Access Report

**Alterations and Additions to
Presbytery Building**

St Patrick's Primary School
65 New England Highway,
LOCHINVAR NSW

For: SHAC
Ref: LP 21515

Figure 1 | Floor Plan showing New Work

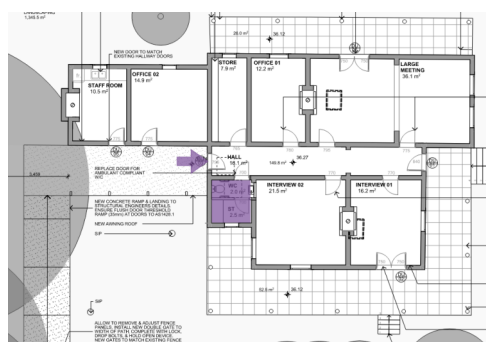
In this instance, there is essentially no **new work** – the interior areas are to be refurbished only and are limited to cosmetic upgrades. Essentially, the only “new work” is the provision of an ambulant toilet and store room that are not required to be accessible.

Figure 2 | Site Plan (in part)

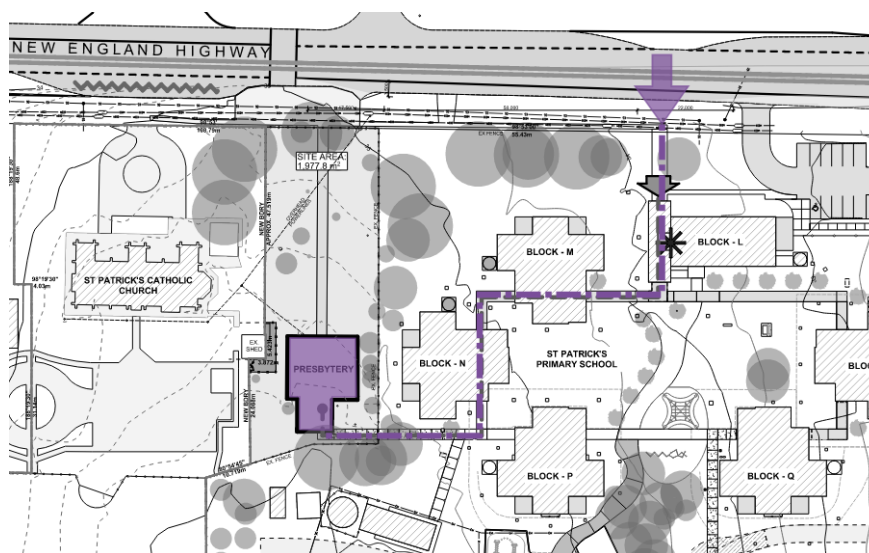
An accessible path of travel is provided from the main school entrance at Block L to the Presbytery Building – existing pathways facilitate an accessible path of travel and a ramp will be constructed for access to the subject building.

All existing buildings within St Patrick's Primary School are accessible being recently constructed / upgraded. The pedestrian network throughout the school facilitates an accessible path of travel to all facilities.

There is no accessible carparking associated within the Presbytery Building. Carparking conditions remain unchanged as a part of its refurbishment.

Appendix 1 | Location of Accessible Learning Support Centres

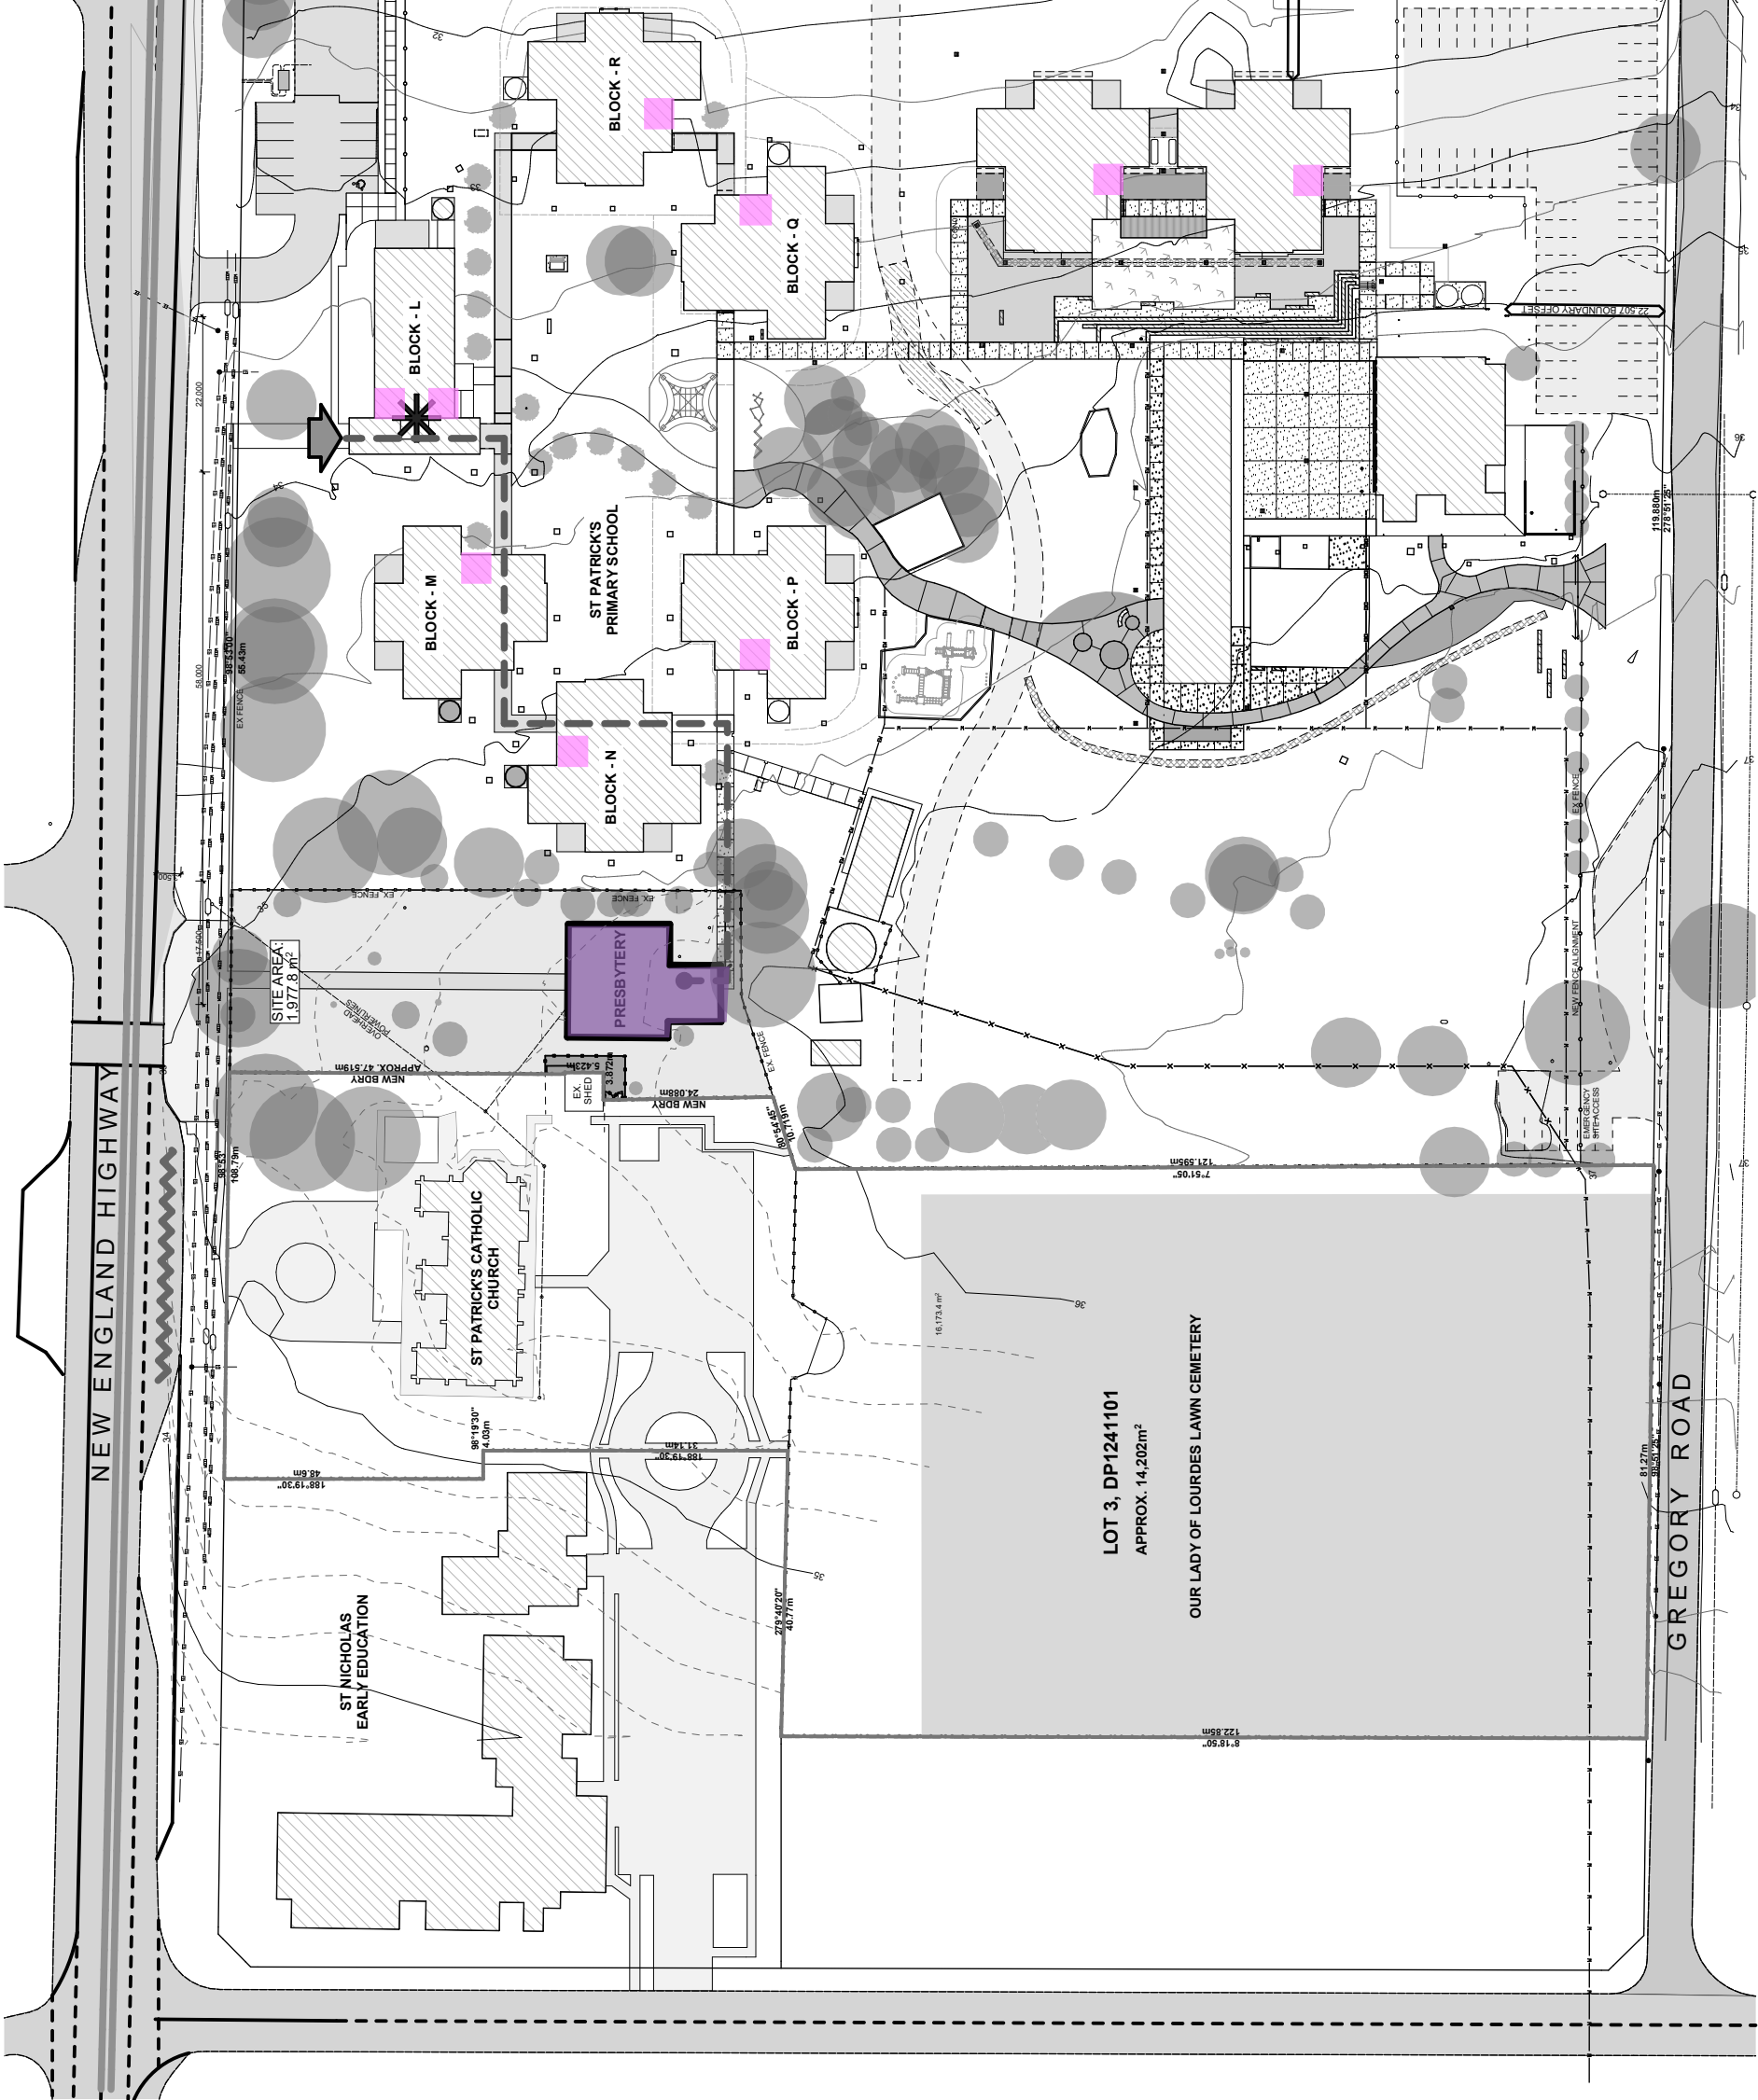
There are nine (9) alternative Learning Support Centres within St Patrick's Primary School and these are evenly distributed throughout the site (Refer to Appendix 1 for locations). These will be utilised by students, staff or volunteers who require an accessible location.

Appendix 2 | Location of Unisex Accessible Sanitary Compartments

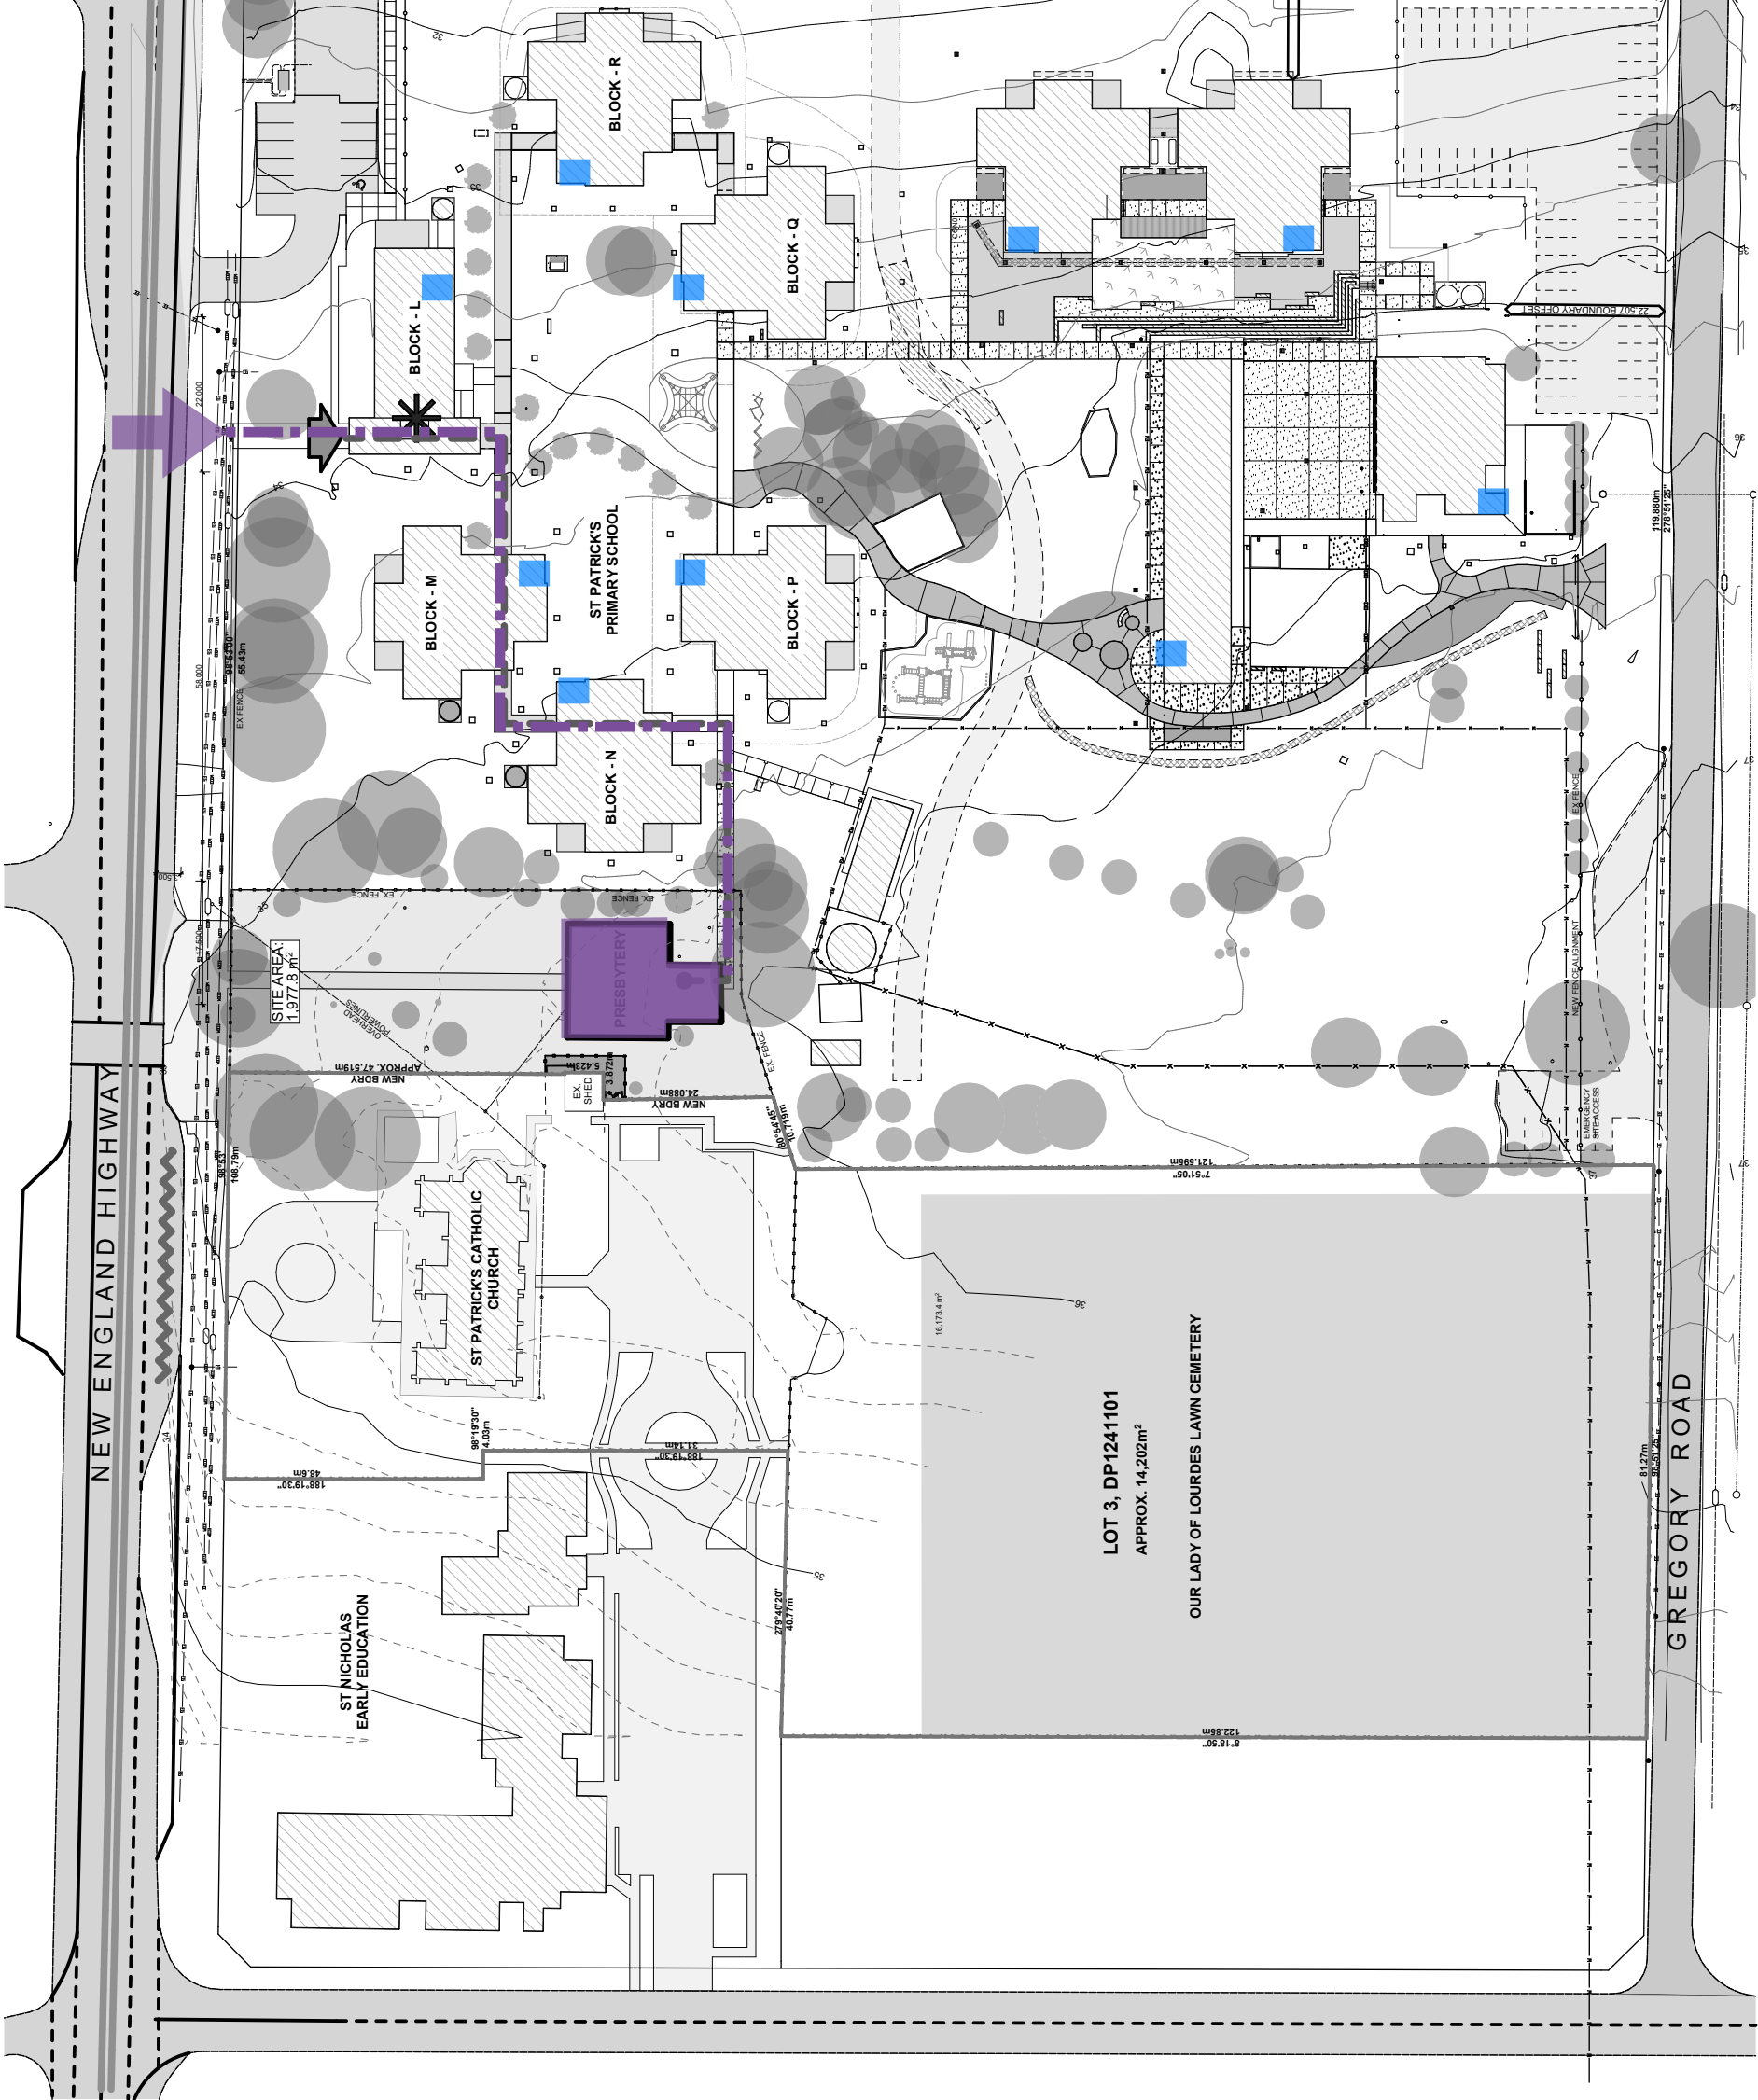
There are unisex accessible sanitary compartments in multiple locations throughout St Patrick's Primary School in association with the accessible Learning Support Centres – refer to Appendix 2 for locations.
